Addendum No. 001

Subject: Mechanical Plant Replacement Bid Package
Mechanical
SDP Contract No. B-045 (c) of 2017/18

Location: Arts Academy at Benjamin Rush
11081 Knights Road
Philadelphia, Pennsylvania 19154

DRAWING NO.
E100

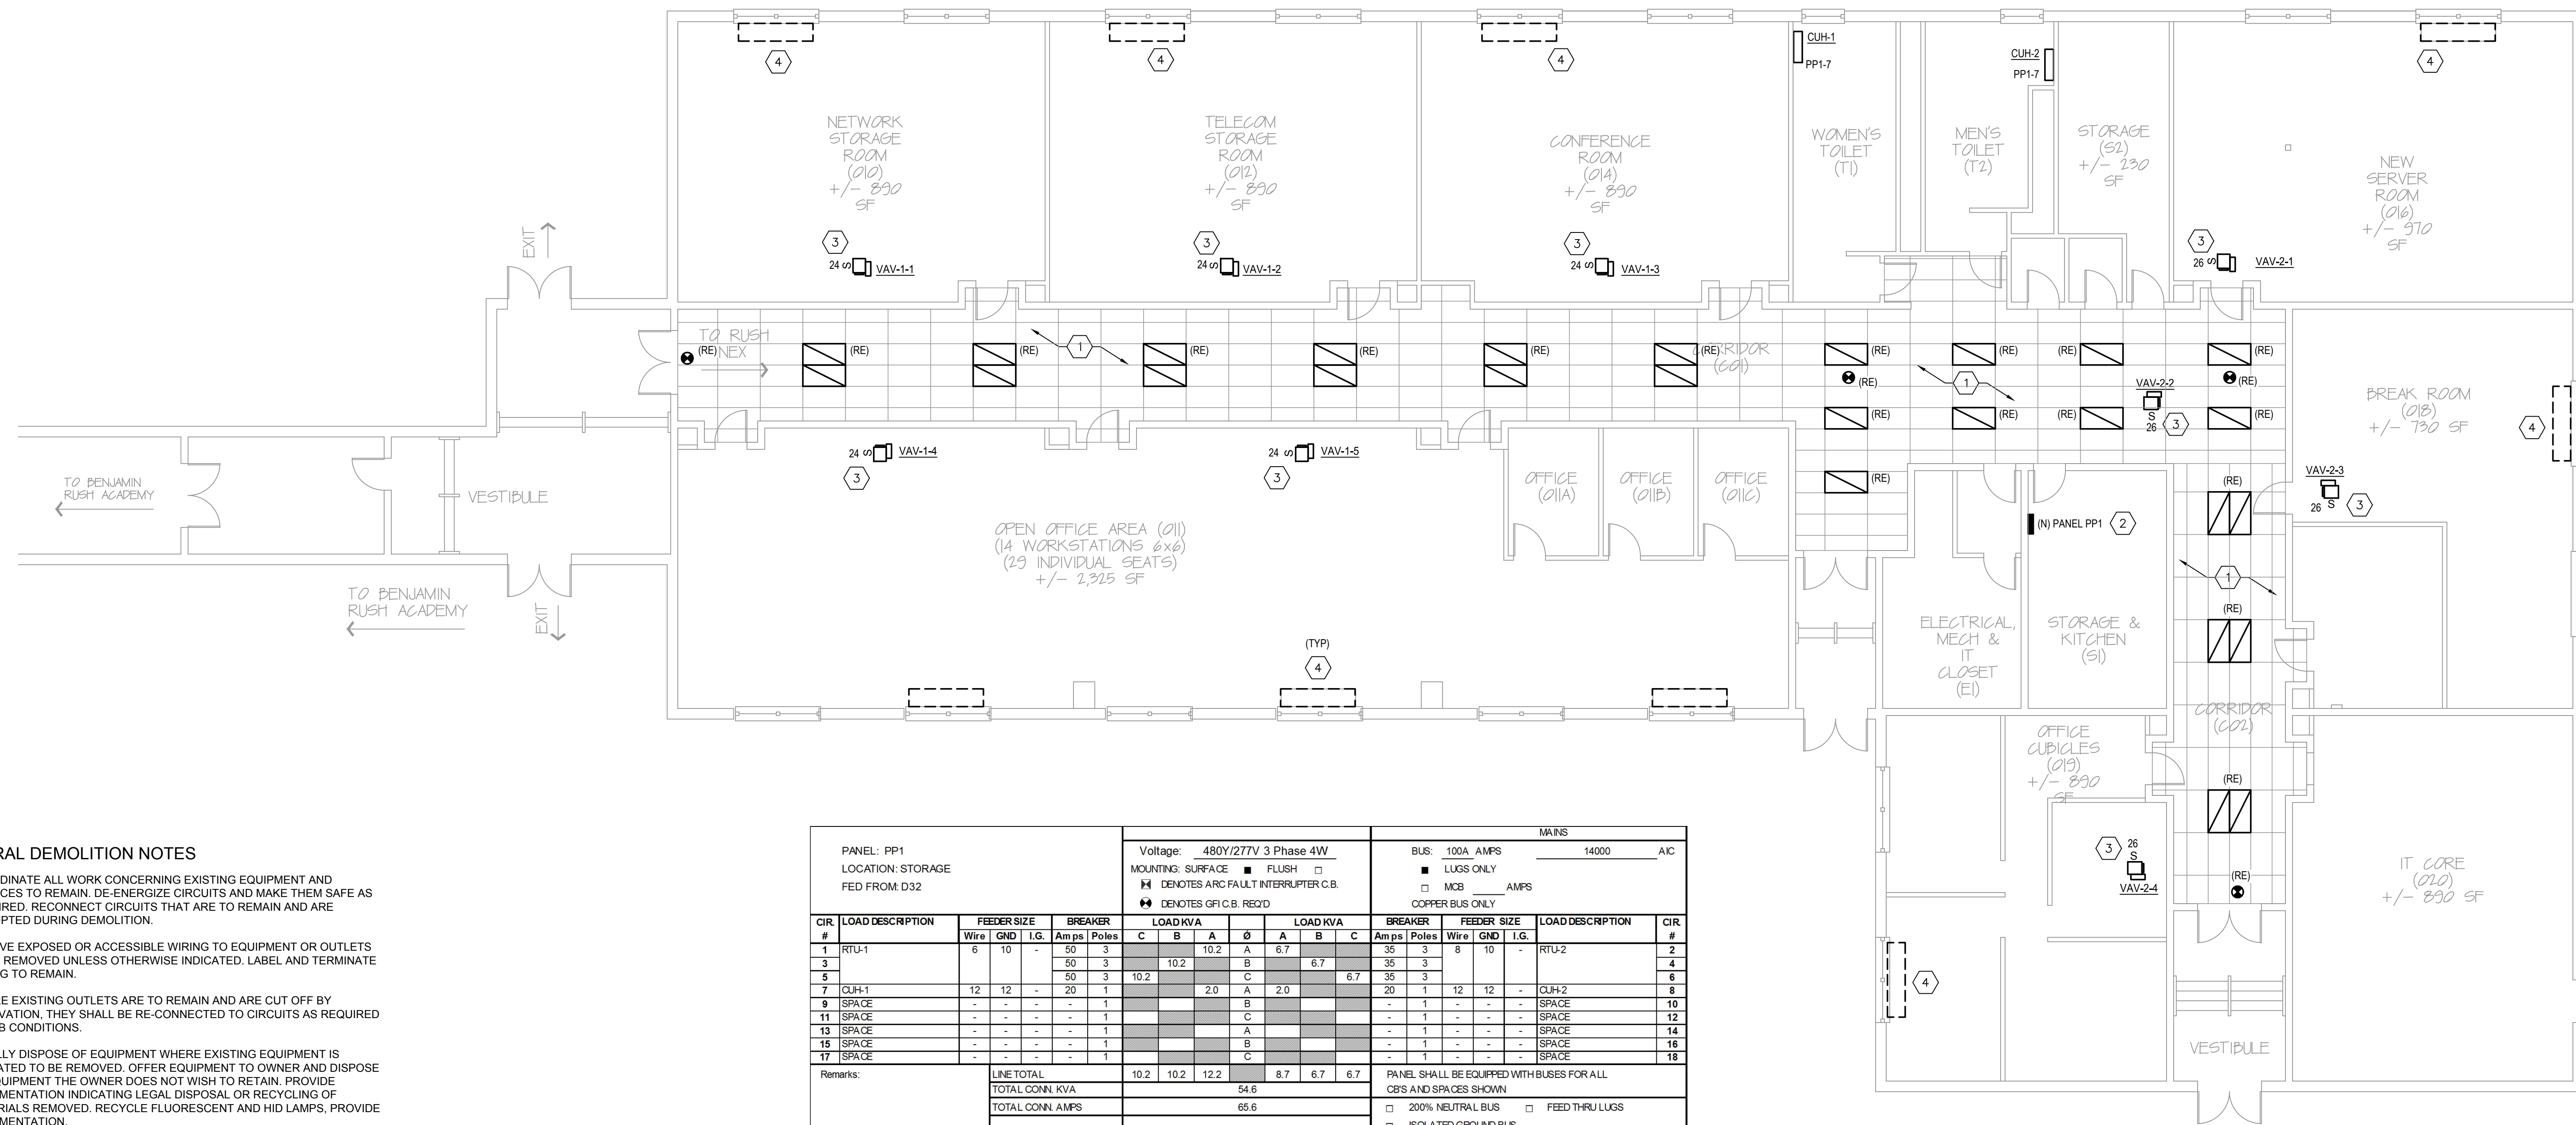
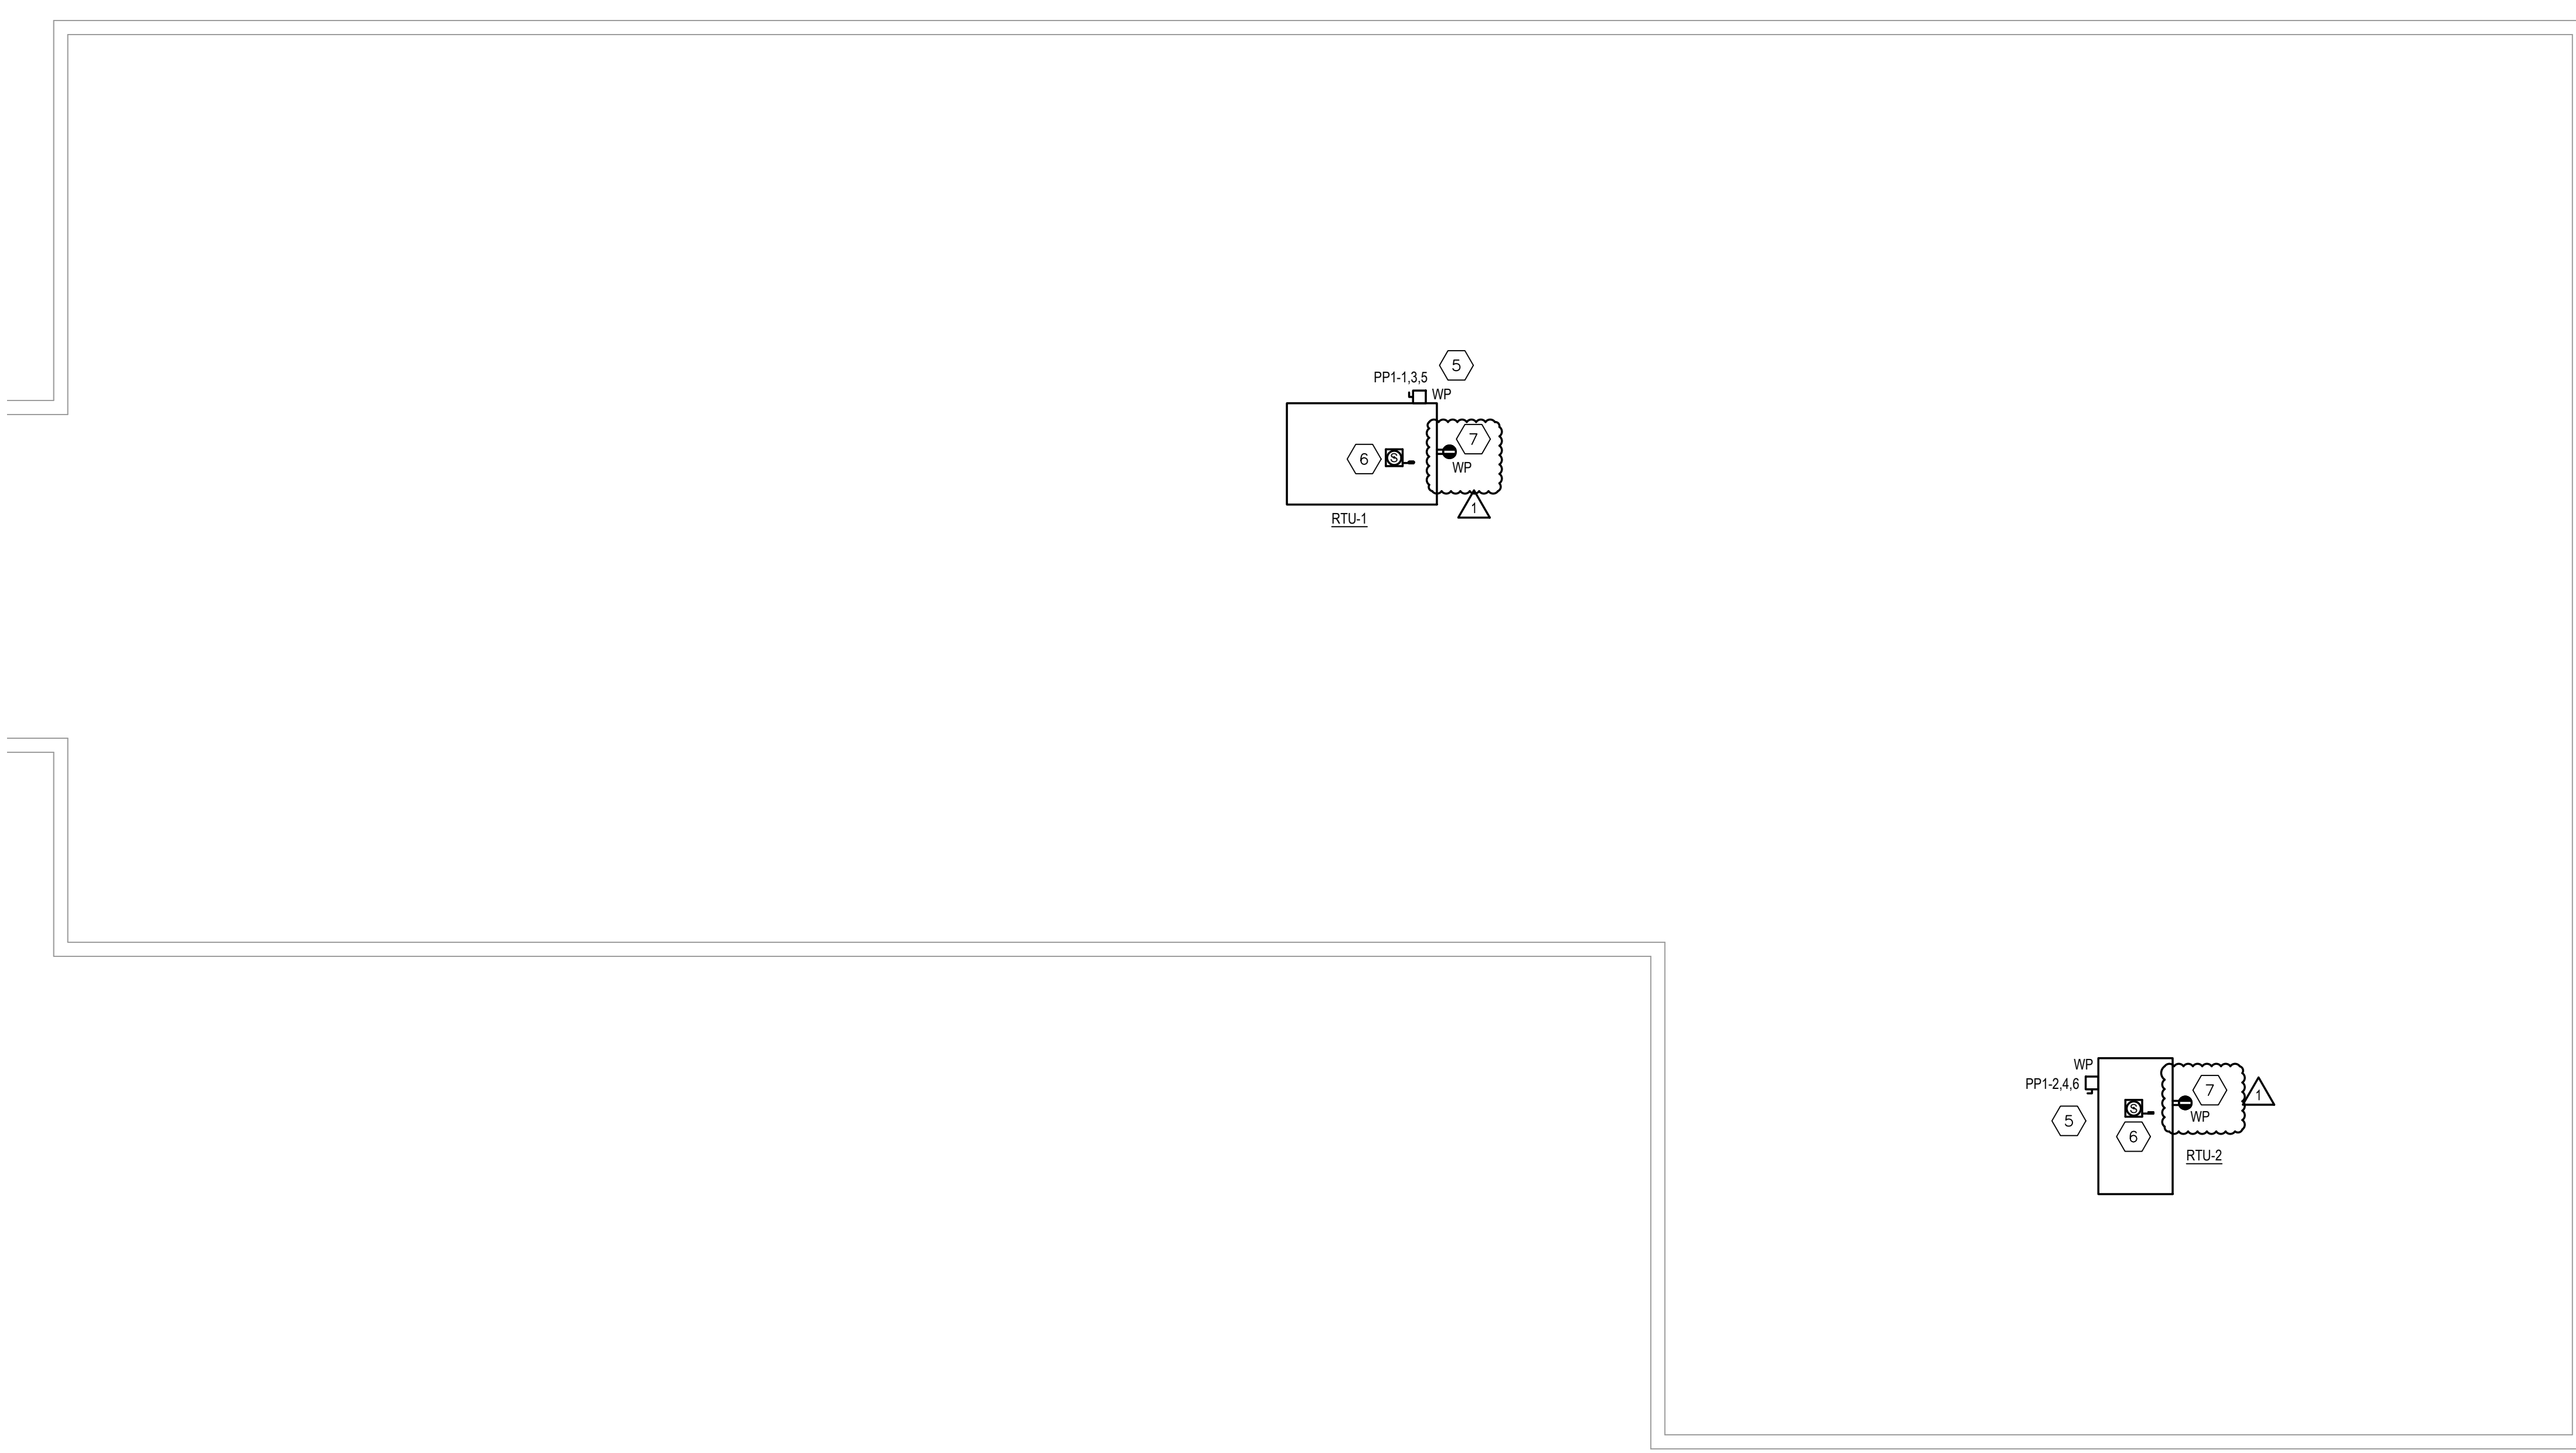
- 2.1.9** Drawing revision E100 – Added convenience receptacles to roof top units. Added Sheet Notes 7 to indicate scope of work.

3.1.1 Are GFCI receptacles required at the two RTU's on the roof?

- Refer to 2.1.9 above.

| SHEET NOTES | |
|-------------|---|
| 7 | CONNECT CONVENIENCE RECEPTACLES TO NEAREST 208/120V PANEL. PROVIDE (2)#12AWG & (1)#12GRD IN 3/4" C. |
